UNITED STATES PATENT AND TRADEMARK OFFICE

APPLICATION NO.	FILING DATE	FIRST NAMED INVENTOR	ATTORNEY DOCKET NO.	CONFIRMATION NO.
10/706,943	11/14/2003	Easton L. Manderson	3023-005	7421

Office Action Summary	Application No.		Applicant(s)	
	10/706,943		MANDERSON, EASTON L.	
	Examiner		Art Unit	
	James L. Swiger		3733

DETAILED ACTION

Figure 1a.

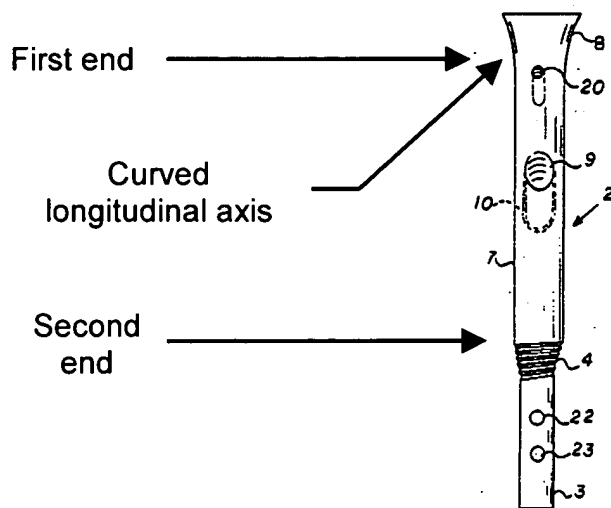
Claims 1-12, 15, and 17-18 are rejected under 35 U.S.C. 102(b) as being anticipated by Marino (U.S. Patent No. 4,733,654). Marino discloses a device having an intramedullary nail (see Fig. 1a below), having a first end and second end, a curved longitudinal axis, an end plate disposed at the first end (see Fig. 1 below), and a distal portion of the device (3).

The above device also has a smaller diameter at the second end, and smaller diameter at the distal shaft area (3).

Marino also discloses that the intended bone is for use on a femur (Col. 2, line 33), and has a hollow core with threads (4), and is capable of insertion without a jig. The end plate can also be viewed by the surgeon in the device of Marino (see Fig. 1 above).

Figure 2.

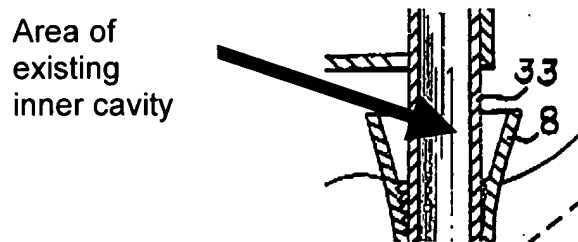
Marino also discloses an aperture formed by an inner periphery (See Fig. 2 below)

closed by the end plate (see Fig. 1 above). Marino further discloses a device having a first screw hole and a corresponding second screw hole in the cylindrically shaped tubular body. (See Fig. 3 below.)
